PITANJA I ODGOVORI
QUESTIONS AND ANSWERS

KONKURS ZA URBANISTIČKO – ARHITEKTONSKO
IDEJNO RJEŠENJE SAJAMSKO – KONGRESNOG CENTRA
U PODGORICI
COMPETITION FOR THE CONCEPTUAL URBAN AND
ARCHITECTURAL DESIGN FOR THE TRADE FAIR AND
CONGRESS CENTRE IN PODGORICA

Glavni grad Podgorica
Njegoševa13, Podgorica
Crna Gora
www.podgorica.me

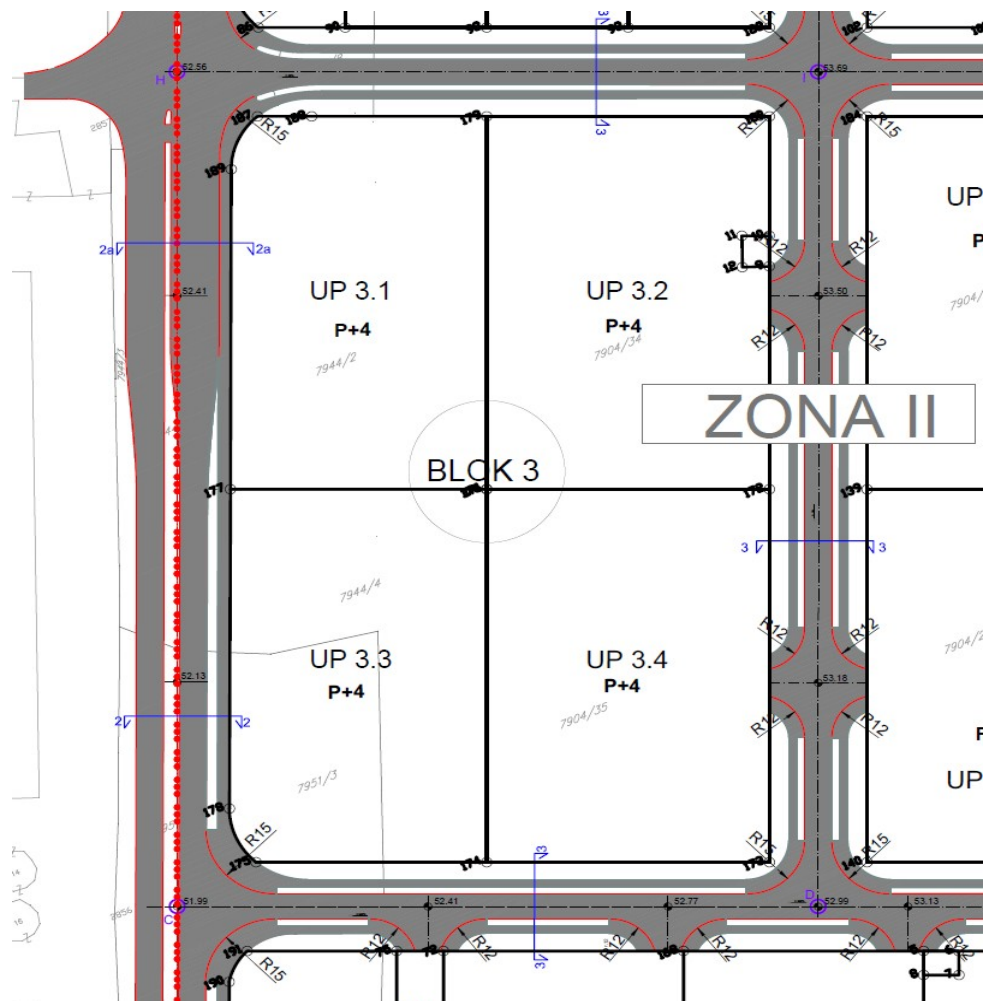
1. Da li je moguće dobiti podatke o okolnim objektima kontaktne zone u smislu gabarita, dimenzija, visina, pozicija na parceli... u digitalnoj formi?
 - a. Duvanski kombinat
 - b. Industrijski pogon – proizvodnja vina („Agrokombinat 13 Jul“)
 - c. Restoran „13 jul“
 - d. Sportsko – rekreativna zona „13. jul“
 - e. Distributivni centar – Zelena pijaca

Is it possible to obtain data about the surrounding objects in the contact zone in terms of massing, dimensions, heights, positions on the plot... in digital form?

- a. Tobacco factory
- b. Industrial plant – wine production (“Agrokombinat 13 Jul”)
- c. Restaurant “13 Jul”
- d. Sports and recreational zone “13. Jul”
- e. Distribution center – Green market

section "General building conditions", it states: The percentage of construction within individual plots or locations should be achieved in the ratio of 50% built-up space and a minimum of 20% free space. Built-up space includes the area under buildings, areas for operational use related to the activity on the site, as well as internal traffic surfaces. In section 10, "Landscape Design Conditions," it states: the total area of green and open spaces should be 30%. In the Competition Program, it is stated as a requirement that a minimum of 38% green areas must be provided. Please clarify – which percentage should be followed?

1. Nažalost, nismo u posjedu digitalnih formata za tražene objekte
Unfortunately, we do not possess digital formats for the requested buildings
2. Vidjeti odgovor na pitanje br. 3, potpitanje br. 7
See the answer to question no. 3, sub-question no. 7
3. U prilogu su dvije fotografije grafičkog priloga i legende
Attached are two photographs of the graphic annex and the legend

4. Potrebno je pridržavati se pozicije urbanističke parcele za Trafostanicu
It is necessary to adhere to the designated location of the urban parcel for the Transformer Station
5. Potrebno je poštovati tabelarni izvod iz DUP-a „Agroindustrijska zona“ – ostvariti minimum 38% zelenih površina
It is necessary to comply with the tabular extract from the Detailed Urban Plan (DUP) "Agro-industrial Zone" – a minimum of 38% green areas must be achieved
